## LiDAR Quality Assessment Report

UT\_GSLSouth\_2011

This data set created using LiDAR points collected from airborne surveys completed between October 13, 2011 and October 18, 2011 and covers approximately 333 square miles contained in the following county(s): Salt Lake County, Utah; Davis County, Utah

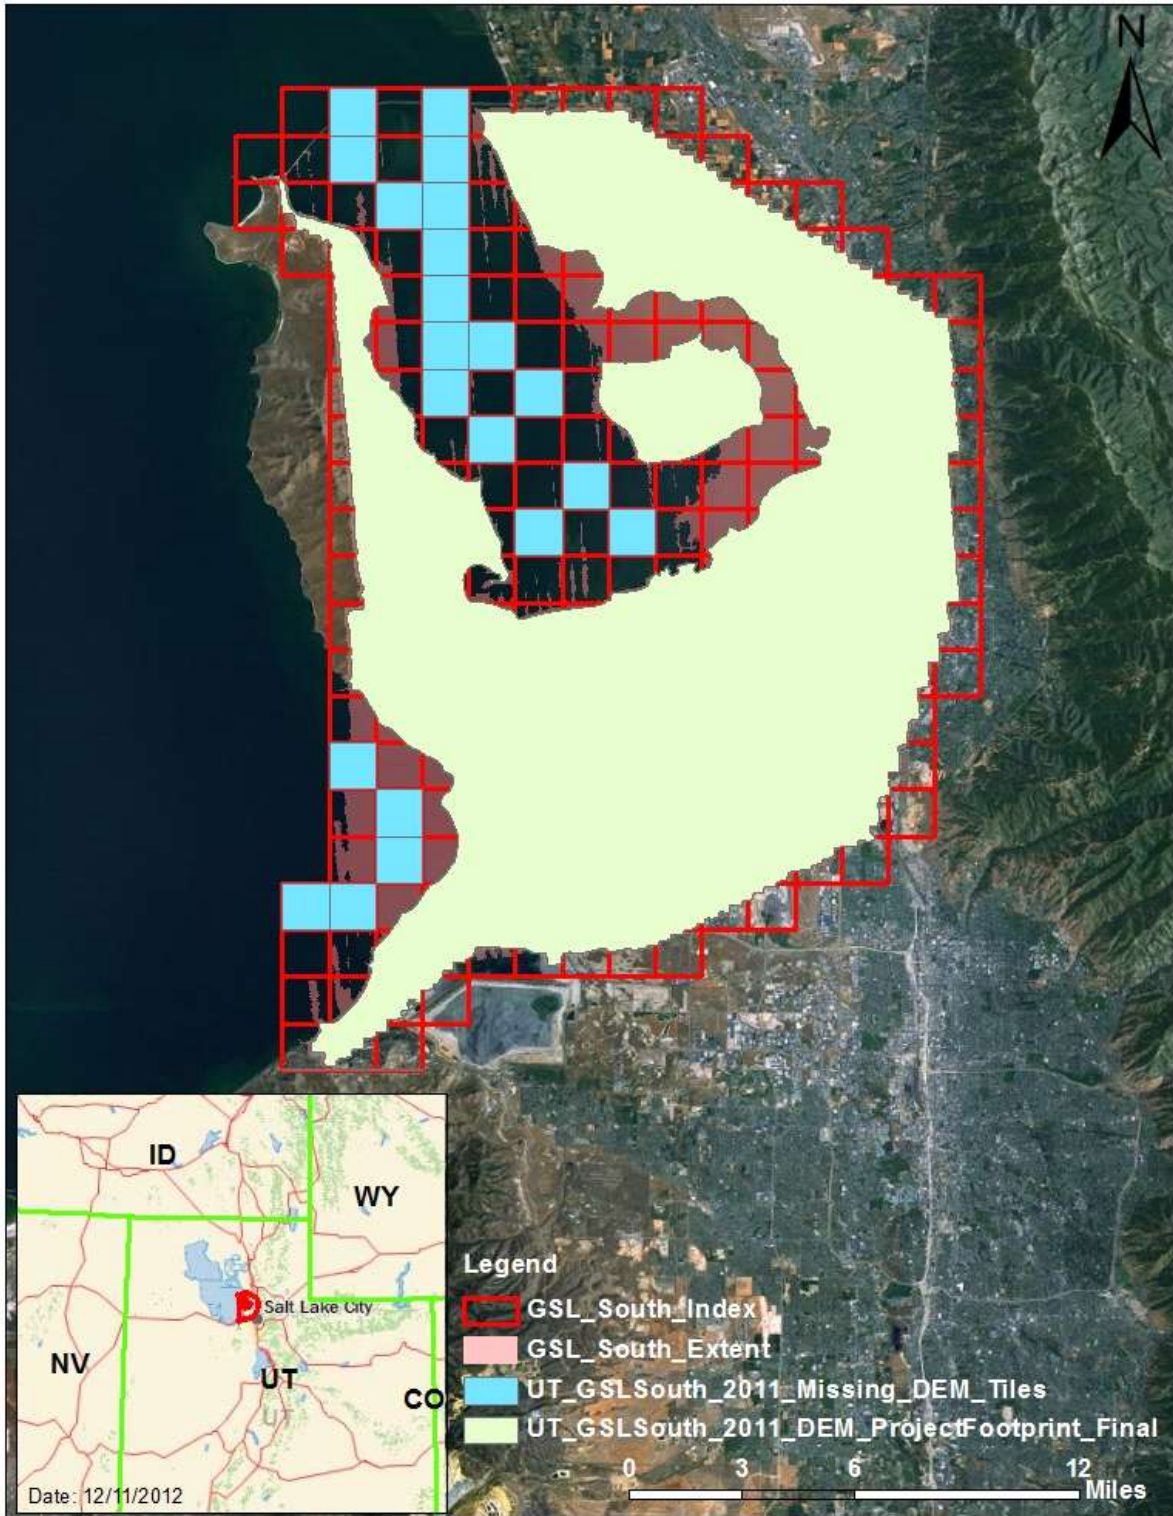
DEM Tiles do not Perfectly Conform to the Tiling Scheme in Terms of Quantity, i.e., 230 DEM Tiles out of a Tile Scheme of 251 Tiles. Missing tiles do not impact the project overall as they fall in areas outside the project extent or unusable data. See [UT\\_GSLSouth\\_2011\\_Missing\\_DEM\\_Tiles.shp's](#) attribute table for a list of missing tiles (pictured above).

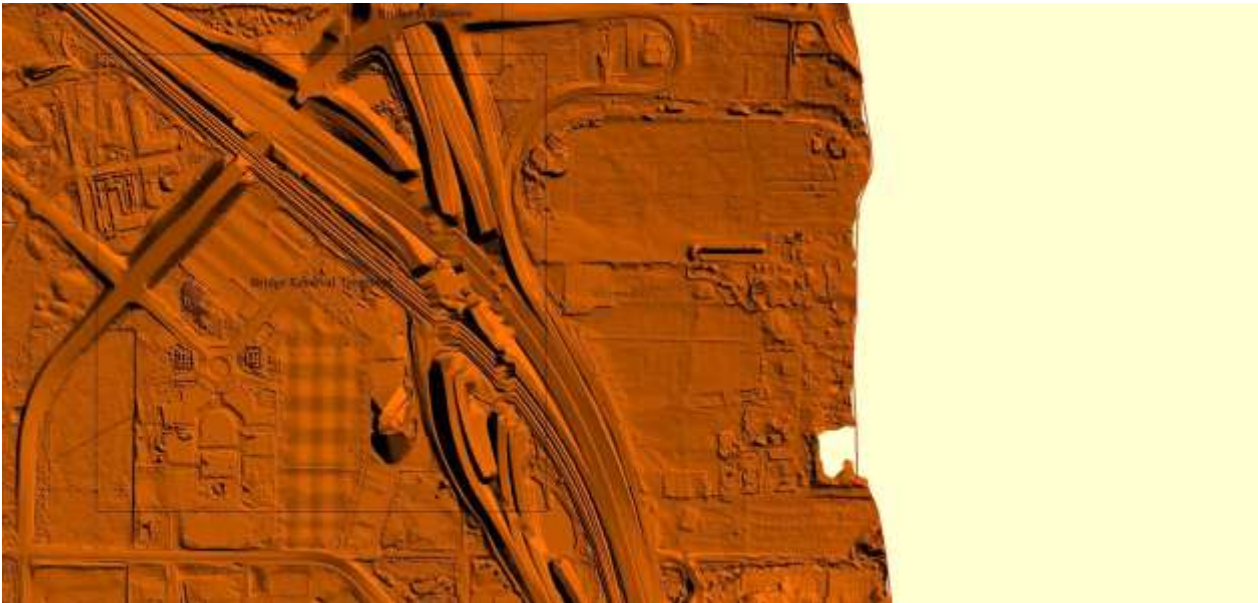
Mosaic of original DEM tiles above, many water areas gridded as "no data".

In order to make the DEM usable in the 1/9th NED the Water needed to have a value, A final mosaic was created by the USGS that coded each interior lake with a constant (flat) value of the lowest bordering pixel. The project boundary for the project was also determined to be the maximum swath extents and was buffered in by 100 Meters and cut out on the southern portion to ensure there were no gaps in the data due to the flight lines. The final product sent to the NED should be free of data voids and have adequate point density for gridded areas included in the final mosaicked DEM. This also has an accompanying DEM Project Footprint and is 221.72 SqMi.

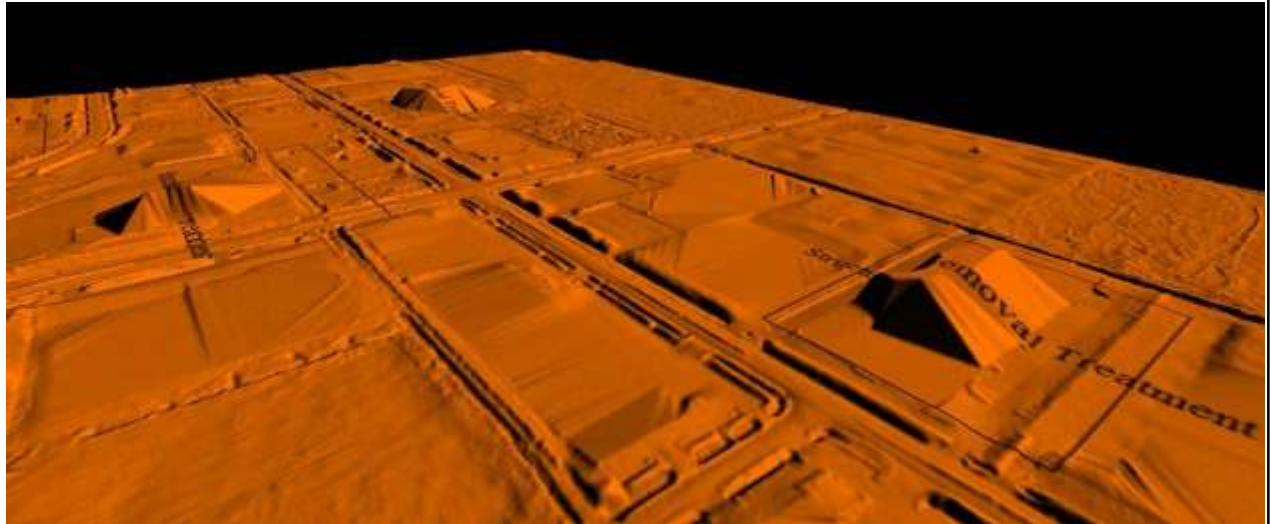
Greater than 100ft nominal width "double line streams" exhibit large amounts of tinning throughout the DEMs.

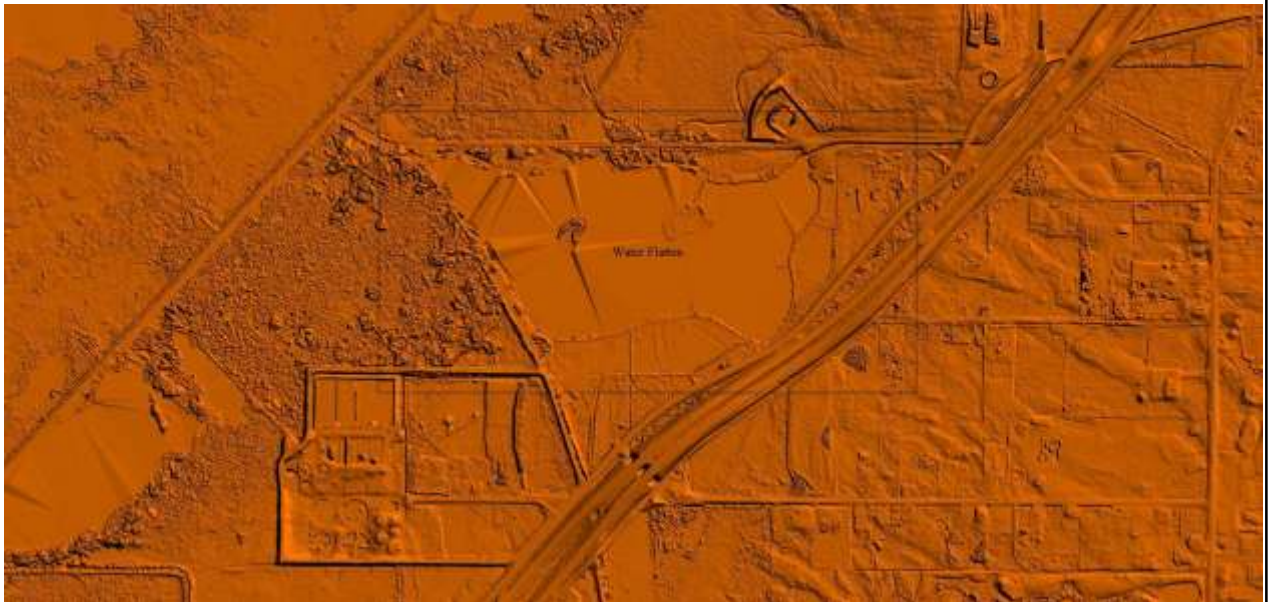
Many Water/Swamp areas, exhibiting heavy amounts of tinning throughout the project. Greater familiarity with the area would be required to make Swamp v. Water leveling treatment recommendations for the areas in question.
